PM7375

Revision F Device Errata

Issue 4: December, 1997

Figure 2.1: Queue Race Condition Example.

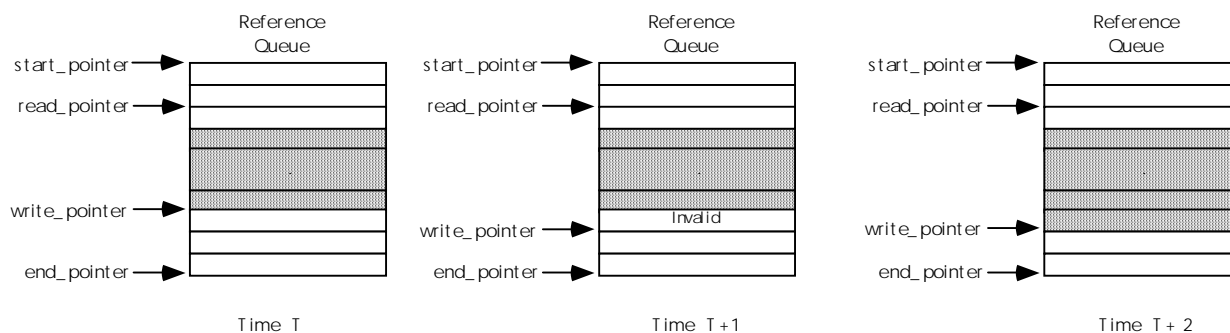
The race condition is that the write_pointer may be incremented before the element is fully written into the queue. When this occurs, the last queue element is invalid until the write operation is fully completed. This is illustrated in the example below:

- At "Time T", the LASAR-155 is ready to insert a new element into the Reference Queue.
- At "Time T+1", the write_pointer is increment before the new element is written into the queue. As a result, the position referenced by the write_pointer contains invalid data.
- At "Time T+2", the new element is added. Now the position referenced by the write_pointer contains valid data.

Figure 2.3 After a Target Disconnect the REQ# is asserted during Idle State.

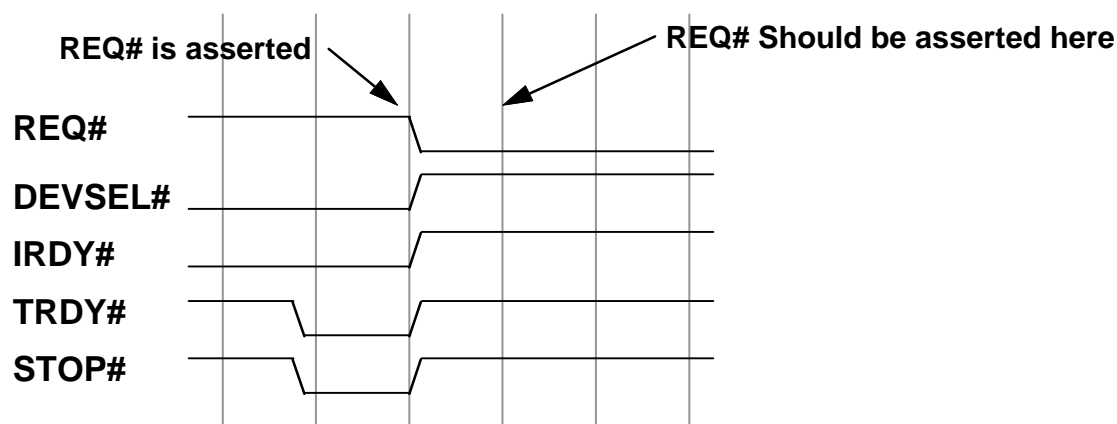
After a target disconnect, the LASAR-155 does not deassert the REQ# for two clock cycles when it should. According to the PCI 2.1 specification, when the current data transaction is terminated by the target, either Retry or Disconnect, the master must deassert its REQ# for a minimum of two clock cycles. These two clock cycles are defined as follows: the first clock cycle being when the bus transitions to the Idle state (at the end of the transaction where STOP# is asserted) and the second either one clock cycle before or one clock cycle after the Idle state. The LASAR-155 correctly deasserts REQ# for one clock cycle before the Idle state and then incorrectly reasserts the REQ# during the Idle state.

The impact of this problem depends on the arbitration scheme used. This problem should not affect normal operation of the PCI bus.

Typical arbitration schemes use a combination of agent priority and round robin access. The LASAR-155 will request the bus one clock cycle earlier than it should. However, other agents will still have access to the bus via the round robin arbitration.
